Accessibility Report

Yorkton

Accessibility Review and Prioritized Recommendations

Project Number: 2025-073

Corridors and hallways should be wide to easily accommodate people moving in both directions. They should be well illuminated and free of obstacles.

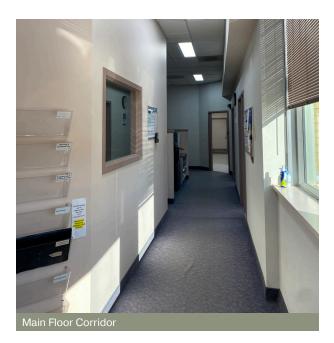
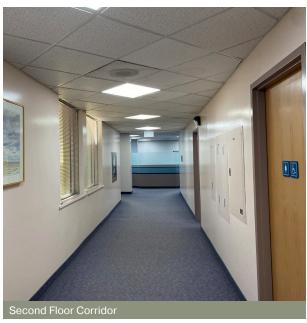
The corridors are typically appropriate in width, but the corridor to the area of refuge is too narrow.

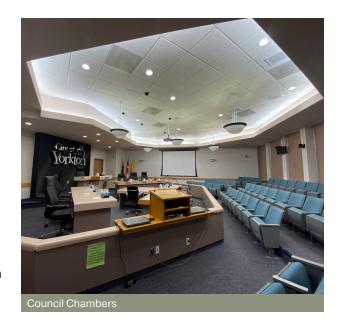
In the second floor boardroom, the knee space at the coffee counter is too low. While there is ample room to move around in the space, the boardroom only has one option for seating.

Sub-total	\$17,000	\$17,500	\$27,500
11	Boardroom has only one option for seating.	Provide additional seating with and without arms.			\$10,000
10	Boardroom knee space in corner is too low.	Replace counter with lower, accessible version, between 730 and 860 mm above floor. Knee space to be at least 685 mm high.			\$5,000
9	Coat rod only available at one height in councilor chambers.	Provide secondary, lower height coat rod in meeting room.	\$500		
8	Councilor and mayor seats only accessible by steps.	Provide low slope ramp for access to councilor and mayor seats.		\$2,500	
7	All chairs in council chambers have arms.	Provide armless options adjacent armed options.			\$10,000
6	Council chambers speaking podium is too high and lacks height adjustability and knee space.	Provide height adjustable podium in Council Chambers. Ensure podium has sufficient knee space.	\$1,500

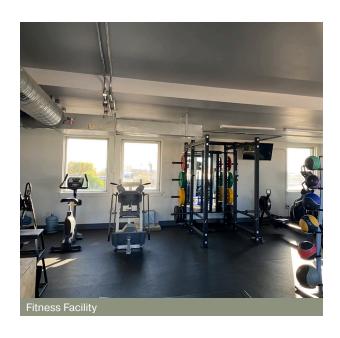
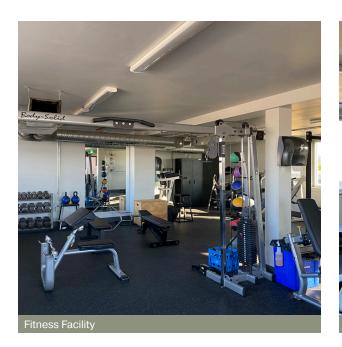
There is a fitness facility located on the third floor of City Hall, but it is only accessible by stairs and lacks designated accessible equipment. The floor to wall contrast is insufficient with very dark flooring. The paper towel is also mounted too high throughout the room.

Item	Concern	Recommendation	Priority and Budget		
			Short Term	Mid Term	Long Term
1	No designated accessible equipment.	Provide a variety of equipment that can be modified to suit accessibility needs.		\$50,000	
2	Insufficient floor to wall contrast.	Paint / install wall base material that has at least 70% contrast with floor.			\$1,500
3	Paper towel is too high.	Lower paper towel to no more than 1100 mm above floor.	\$500		
4	Floor is dark.	Replace dark flooring with lighter colour.			\$15,000
Sub-total Sub-total			\$500	\$50,000	\$16,500

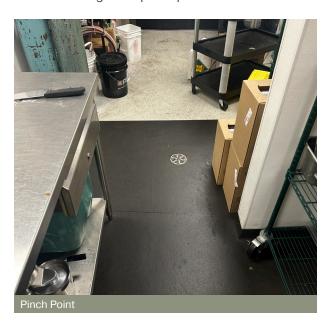
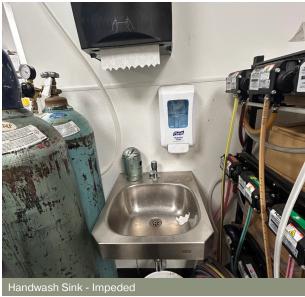
The Deer Park Clubhouse has a restaurant with a commercial kitchen that serves the dining area, along with a Snack Shack that is accessed from the exterior of the building. The kitchen lacks accessible features for receiving, serving and preparing food. Many of the counters, fixtures, and equipment are located too high and pinch points are created between walls and workspaces.

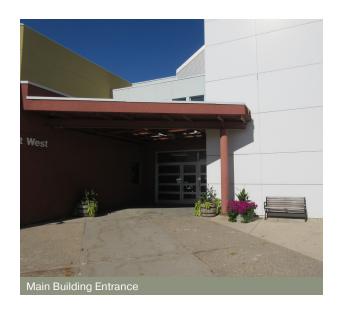
Inside the vestibule, the contrast between the flooring and walls is insufficient and there is a black mat on the floor.

Corridors and Hallways

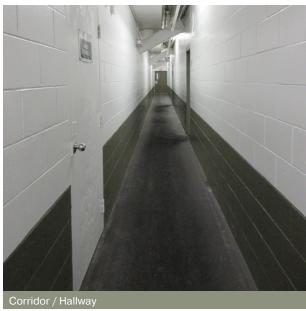
Corridors in the Gallagher center are sufficiently wide enough and allow for a logical and direct facility layout. Corridors have contrasting patterns and colours within the floor and do not have enough contrast between the floors and the walls.

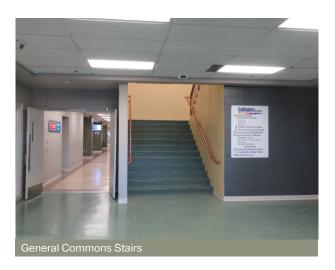
There are three feature interior stairs at the Gallagher Centre that are easily located. However, they lack many accessibilities features making ease of use more difficult for a variety of users.

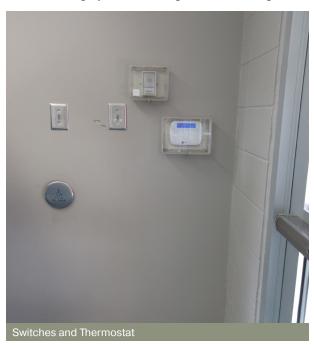
Most building systems throughout the Gallagher Centre are located too high.

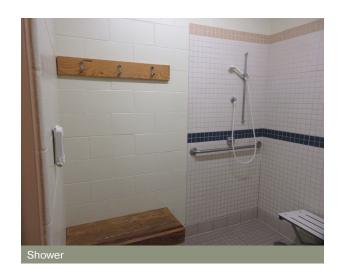
The Gallagher Centre has multiple different shower locations throughout the facility. At the time of review, the only functioning accessible shower was noted in the aquatic facilities family changeroom. All other showers within the Arena and Flexi-hall were either not accessible or non operating.

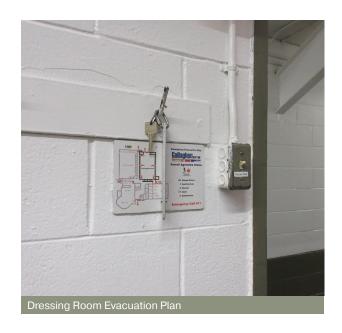
There are evacuation instructions located throughout the facility. These instructions are only presented in one format and are difficult to read.

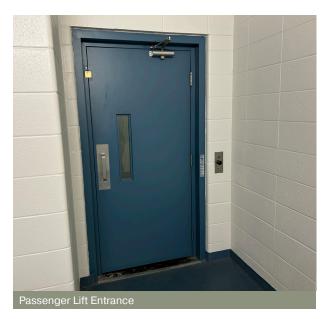
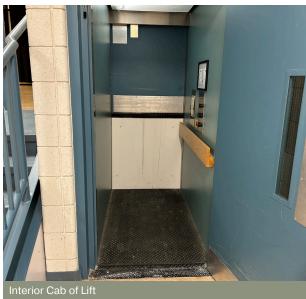
There is one passenger lift in the Gloria Hayden Community Centre that provides access to the walking track; however, it lacks many features that would make it accessible. The lift does not have sufficient width, requires an attendant to operate and is not an enclosed space. It also lacks contrast, handrails, signage and is overall insufficient.

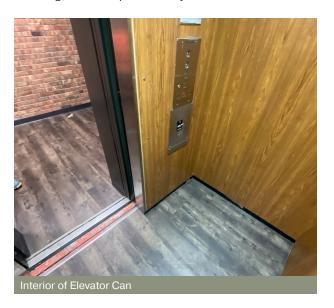
The elevator is quite far from the accessible entrance and lacks several accessibility features such as railings, audible indication of floors, Braille on buttons, etc. There is a lift at the stairs in the Land Titles building, but it requires a key to use.

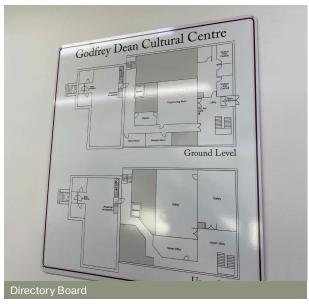
There is one directory board located in the main entrance lobby. The map has glare with graphics that are not clear (i.e. Light weights, contrast, symbols, etc.).

Item	Concern	Recommendation	Priority and Budget		
			Short Term	Mid Term	Long Term
1	Only provided in one format.	Provide directory signage in alternative formats.	\$2,500		
2	Signage has glare.	Replace directory signage with matte / non-glare version.	\$1,500		
	Sub-total			\$0	\$0

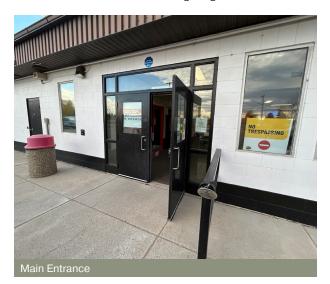
The main entrance is easily identified; however, lacks an entrance canopy, vestibule, and sufficient contrast between the door and adjacent glazing. The push button door actuator is only at one level and was not tested due to the ongoing construction occurring in the building.

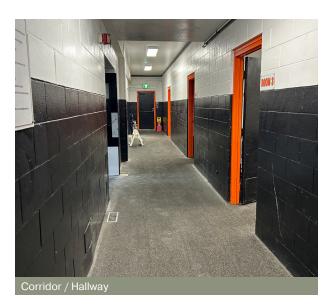
The corridors in the Kinsmen Arena are sufficiently wide enough but lack contrast between the walls and floors. Long stretches or hallway should include a railing.
